STAFF ANALYSIS

Case No.:	CZ-25-1247294	File ID #: 2024-1442	
Address:	1716 Pleasant Hill Trail, 7778, 7860, 7890, 7900, 7956 & 8024 Pleasant Hill Road	Commission District: 05	Super District: 07
Parcel ID(s):	16-197-03-006, 16-197-03-012, 16-219-01-005, 16-219-01-006, 16-220-01-004 16-220-01-007 & 16 220 01 009		
Request:	Major modification of Conditions #1 and #4 of CZ-18-22130 for the development of single-family detached dwellings within the RNC (Residential Neighborhood Conservation) Zoning District.		
Property Owner(s):	Hybrass Properties, LLC.		
Applicant/Agent:	Hybrass Properties, LLC. c/o Battle Law, P.C.		
Acreage:	95.52 acres		
Existing Land Use:	Single-family dwellings/vacant		
Surrounding Properties:	North: R-100, MU-1 East: RNC, R-85 South: R-85 West: R-85		
Comprehensive Plan:	Suburban (SUB)	Consistent	Inconsistent X

Staff Recommendation: TWO-CYCLE DEFERRAL

CONCEPT PLAN
 FOR
PLEASANT HILL

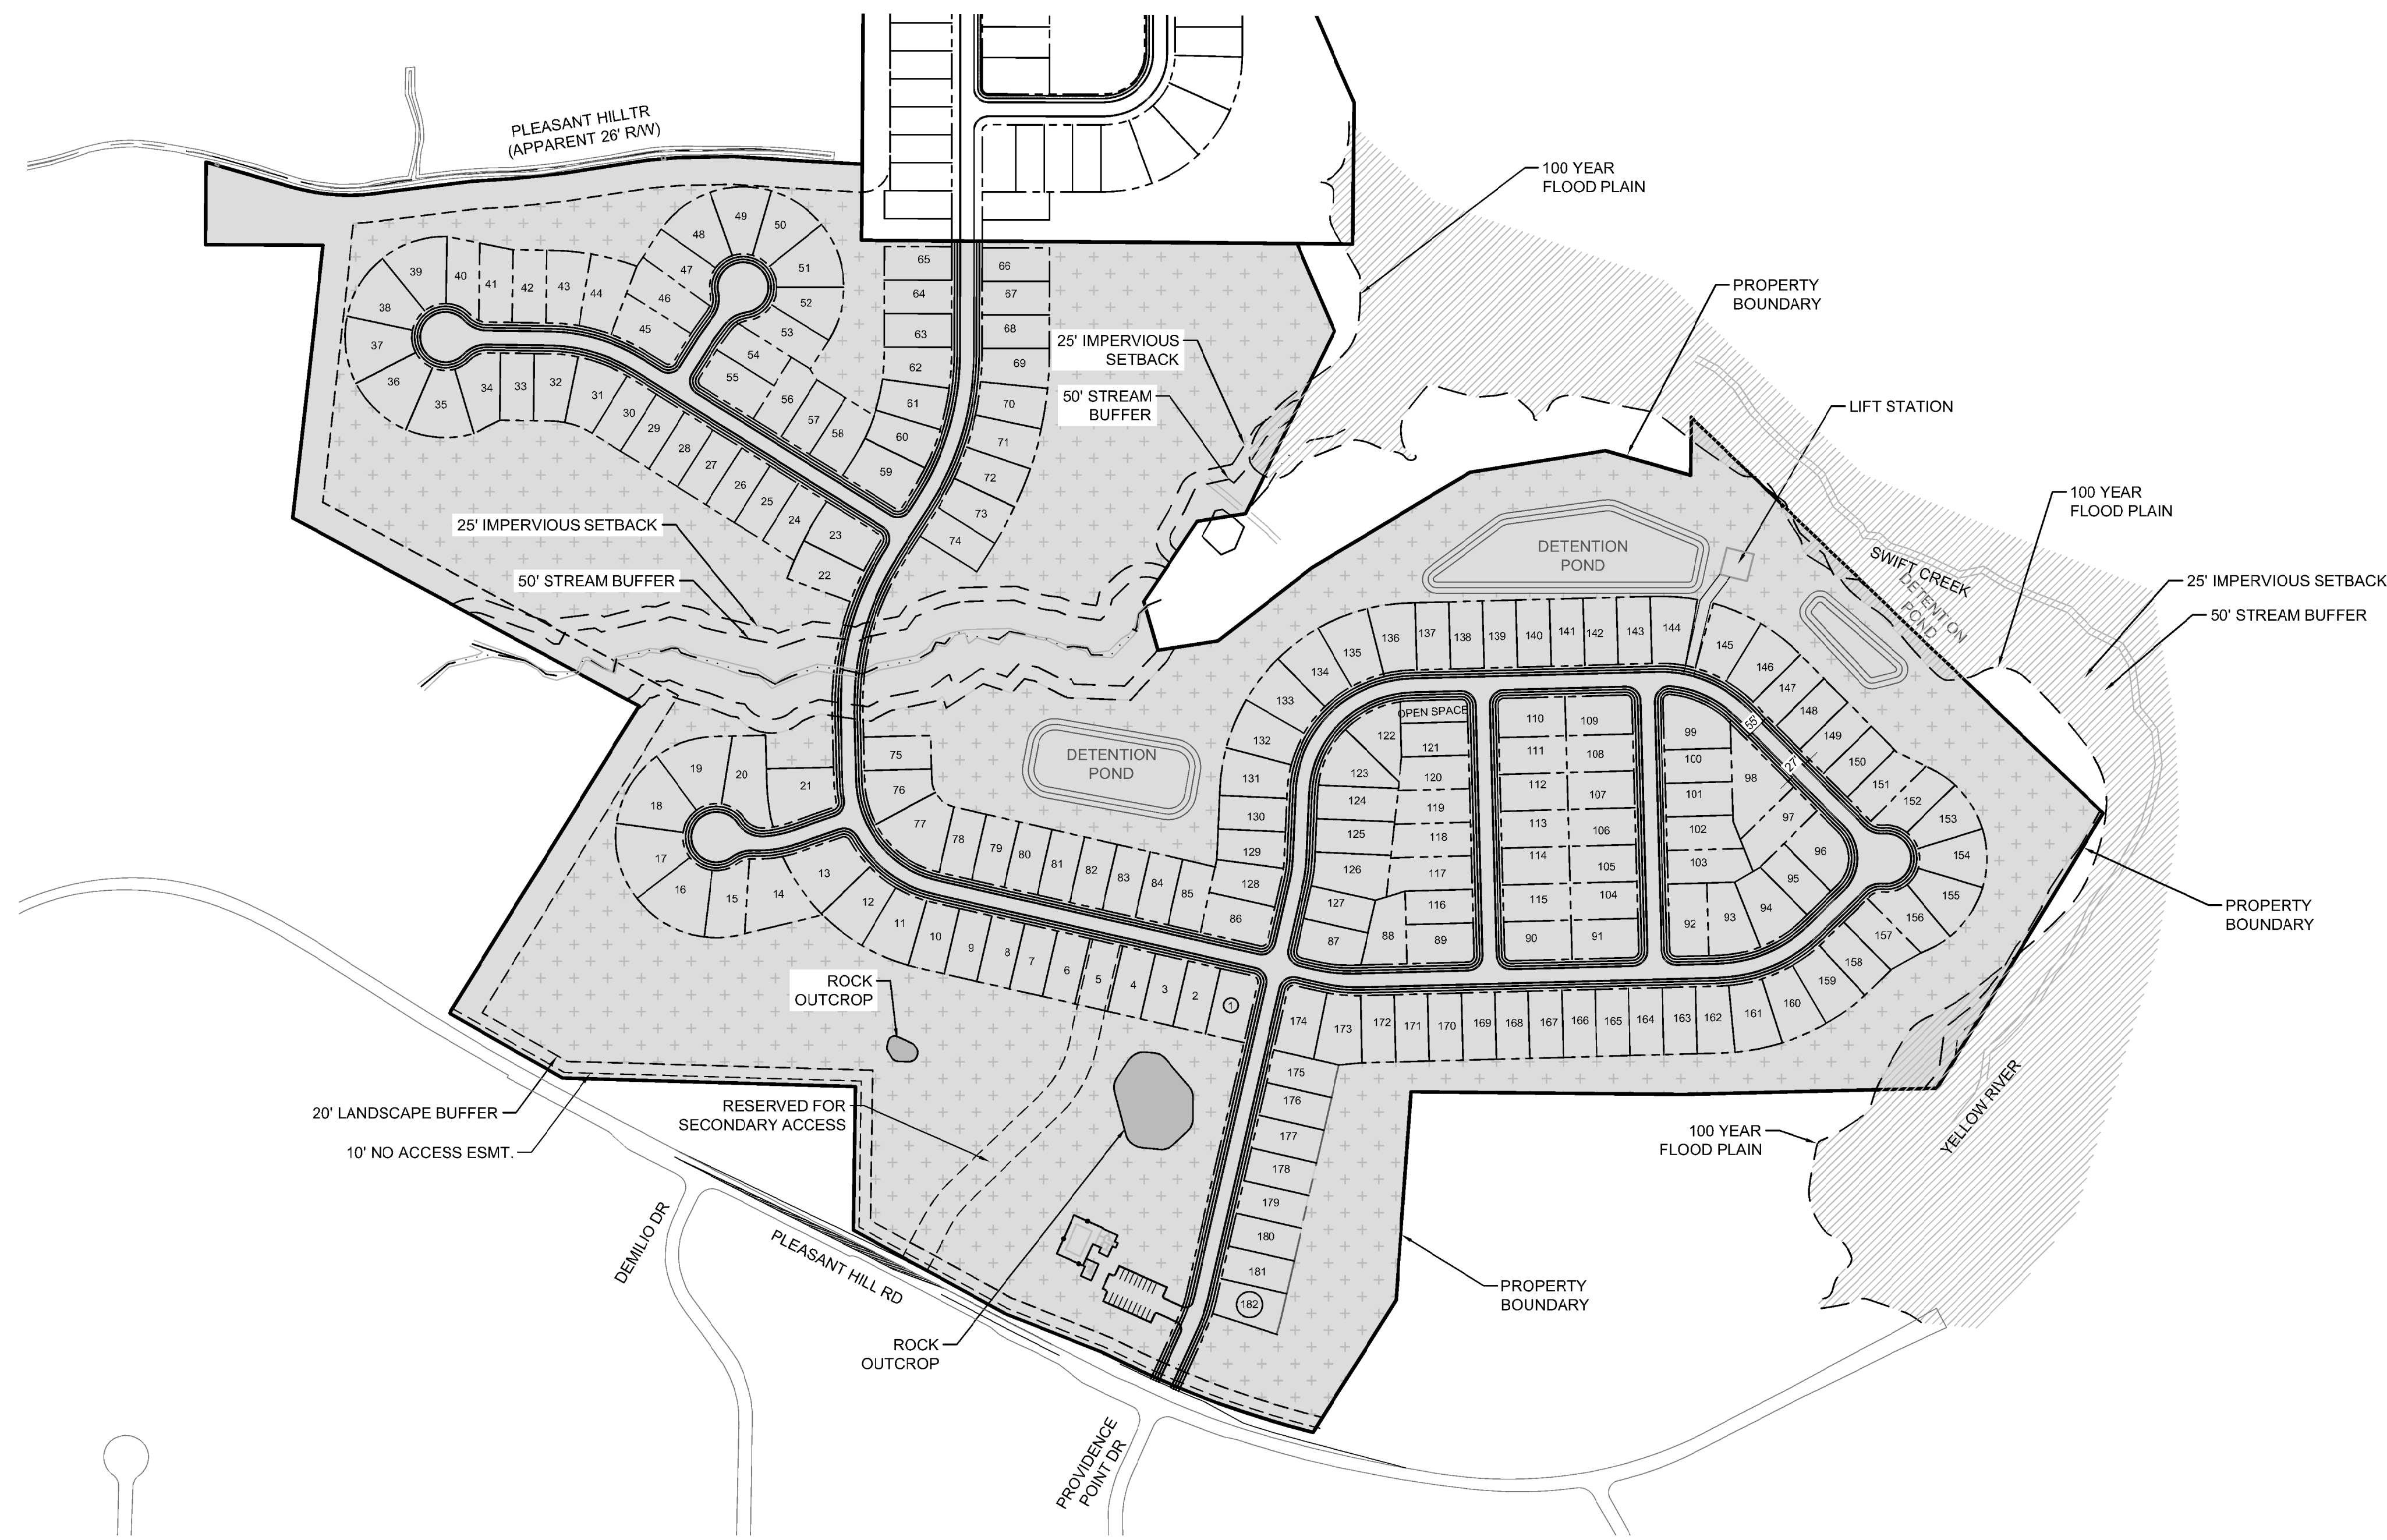
A modification of Condition #4 would relocate the originally proposed access points along Pleasant Hill Road to accommodate topography. One of the access points would connect to a proposed subdivision to the north of the development site; notably, however, Current Planning has yet to have received a Sketch Plat application for such a subdivision. An additional access point would be provided only for emergency vehicles. Per the current site plan, only (1) of the three (3) access points would be for regular traffic off of Pleasant Hill Road, which has raised concerns from Staff as well as the surrounding community.

While the reduction of units allows for the potential preservation of greenspace that is encouraged with RNC developments (see Section 2.10.2. of the *Zoning Ordinance*), there are still potential issues with topography that may affect the configuration and/or potential lot yield with the development. Namely, the new site plan does not appear to prove compliance with the minimum greenspace requirement as defined per Section 2.10.5. of the *Zoning Ordinance*. A minimum of 30 percent of the total site area shall be dedicated to greenspace, which may not consist of the following features (per Section 2.10.5.(B)):

The submitted site plan shows a development that appears to have extreme slopes throughout, as well as having state waters/stream buffers. Meeting this greenspace requirement could pose a challenge for development and could affect lot yield.

N5. CZ-25-1247294 - 7778 Pleasant Hills Road, etc. - Phase 1 has 182 lots and requires 3 access points (Sec. 14-200 (5)). Verify the reserved secondary access point meets the minimum spacing outlined in 14-200 (6) and has the required sight distance. Please see infrastructure requirements in Zoning Code 5.4.3 and Land Development Code 14-190. Pleasant Hill Road is a classified as a minor arterial (45MPH). Requires a right of way dedication of 40 feet from centerline OR such that all public infrastructure is within right of way, whichever greater. Requires at least an 11-foot travel lane with curb and gutter. Requires a 10-foot landscape strip (with at least 5 feet between the back of curb and the sidewalk/path), 6-foot sidewalk with 4-foot bike lanes OR (preferred) 10-foot multiuse path in lieu of sidewalk and bike lane. Street Lighting required. (hefowler@dekalbcountyga.gov). Pleasant Hill Road is classified as a local road. Requires a right of way dedication to 27.5 from centerline OR such that all public infrastructure is within right of

As a result of meetings with Current Planning Staff, the applicant has requested a deferral of the proposal to revise their site plan and provide additional information. In coordination with the applicant's request, the Planning and Sustainability Department recommends a *Two-Cycle Deferral* to address the above issues.
